Access Compliance Report

Public Rights-of-Way

Intersection ID: 32287	Main Street: ALLYSON_PARK_DR	Cross Street: BAILEYWICK_RD	Location: SW
ADA ID: 474123793B96	Ramp Type: PerpDiag	Initial Pass/Fail: Fail	Overall Compliance: No
Codes/Mitigation Info/Possible Solution		Field Measurements/Component Compliance

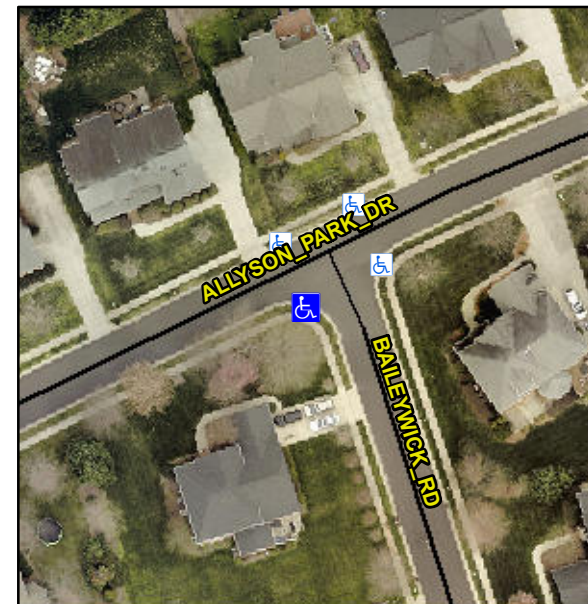
Not Found, R304.5.1, R304.2.2, R304.5.3

Compliance	Description	Data	Compliance	Description	Data
N/A	Ramp Length (in)	51.0	No	Ramp Slope (%)	10.8
No	Ramp Width (in)	44.0	No	Ramp XSlope (%)	5.6
N/A	Flare Type LT	N/A	N/A	Flare Type RT	N/A
N/A	Flare Slope LT (%)	N/A	N/A	Flare Slope RT (%)	N/A
N/A	Flare Traversable LT?	N/A	N/A	Flare Traversable RT?	N/A
N/A	Landing Length (in)	N/A	N/A	DWS Provided?	N/A
N/A	Landing Width (in)	N/A	N/A	DWS Contrast?	N/A
N/A	Landing Slope (%)	N/A	N/A	DWS Length (in)	N/A
N/A	Landing X Slope (%)	N/A	N/A	DWS Full Width?	N/A
N/A	Landing Curb? (Y/N)	N/A	N/A	DWS Offset (in)	N/A
N/A	Shared Landing?	N/A			
N/A	Gutter Ponding?	N/A	N/A	Gutter Slope (%)	N/A
N/A	Gutter Lip Ht (in)	N/A	N/A	Gutter X Slope (%)	N/A
N/A	Painted X Walk1?	No	N/A	Painted X Walk2?	No
	X Walk 1 Direction	To NE		X Walk 2 Direction	To N
N/A	X Walk 1 Width (in)	N/A	N/A	X Walk 2 Width (in)	N/A
	X Walk 1 Slope (%)	1.5		X Walk 2 Slope (%)	4.0
	X Walk 1 X Slope (%)	1.7		X Walk 2 X Slope (%)	2.3

Remove & Replace Curb Ramp With Two New Directional Ramps or Equivalent.
